# BGA ENGINEERING NEWS

Number 8, September 2001

## RUNNING MODIFICATIONS ON CARBURETORS FOR ROTAX<sub>o</sub> 2-STROKE UL AIRCRAFT ENGINES SL-2ST-005

Bild 1

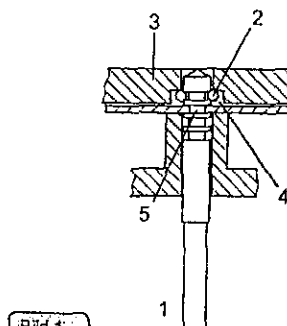
- Damping of jet needle (1) against vibration by additional O-ring (2) 2,5x1,5 (see fig. 1).

■ **NOTE:** This O-ring can be installed on older carburetors only if a new spring cup (3) is fitted, as for the additional O-ring (2) a recess (4) in the spring cup is necessary.

Bild 3

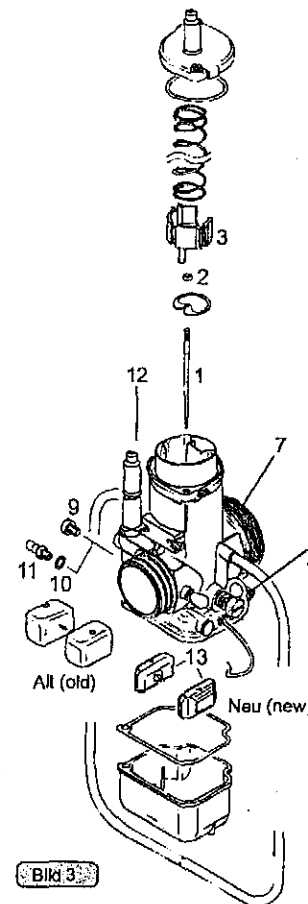
- The suction side carburetor flange (7) is furnished with a thread groove to increase the hold of the intake system (airfilter, intake silencer etc.). See fig. 3.
- The idle air regulating screw (8) is provided with a hexagon head (wrench 13 mm) instead of knurled head. See fig. 3.

- All new carburetors have a depression connection for the high altitude kit (HAC kit). See fig. 3.

◆ **NOTE:** Normally this connection is plugged with a screw (9) M6x5. If the HAC kit is to be connected, this screw is replaced by the sealing ring (10) and hose nipple (11).

view: puller assy  
Fig. 4 and 5

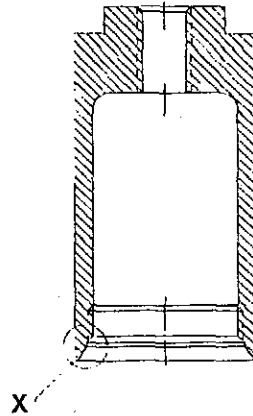
Because of the changed assembly procedure the puller (9) for the layshaft gear has been modified. The new tool is fashioned with a chamfering at the base of the puller (9), thus achieving the best stability at pulling-off procedure. Furthermore the other end of the puller is now flat sided 36 A/F to lighten the puller (9) into position.
